# UNITED STATES PATENT AND TRADEMARK OFFICE

APPLICATION NO.	FILING DATE	FIRST NAMED INVENTOR	ATTORNEY DOCKET NO.	CONFIRMATION NO.
10/720,278	11/25/2003	Alain Poiraud	2937-115	4789

<b>Office Action Summary</b>	<b>Application No.</b> 10/720,278	<b>Applicant(s)</b> POIRAUD, ALAIN	
	<b>Examiner</b> Ajay Vasudeva	<b>Art Unit</b> 3617

## DETAILED ACTION

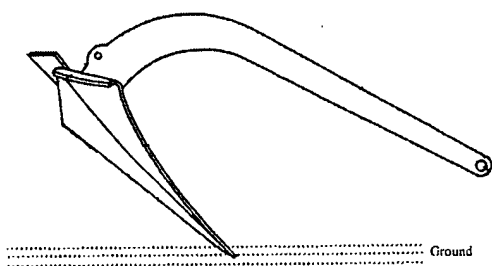
Re claims 5 and 12, in certain instance – such as when the anchor is tipped in an orientation shown below -- most of the weight of the anchor would be borne by the tip of the anchor. In such orientation, the proportion of the weight of the anchor on the tip would be higher than 20%. It is noted that claim 5 has not set forth the claimed weight distribution in an anchored position.

Alternatively, under certain other conditions – such as when the anchor is resting in an anchoring position on an sloped seabed/surface, and the tip of the fluke is positioned down slope – the proportion of the weight of the anchor on the tip would again be higher than 20%. Applicant may also note that a seabed is not always a level ground, and anchors are capable of settling in any one of countless positions on an uneven floor in which the weight borne by the tip of the anchor would be higher than 20%.
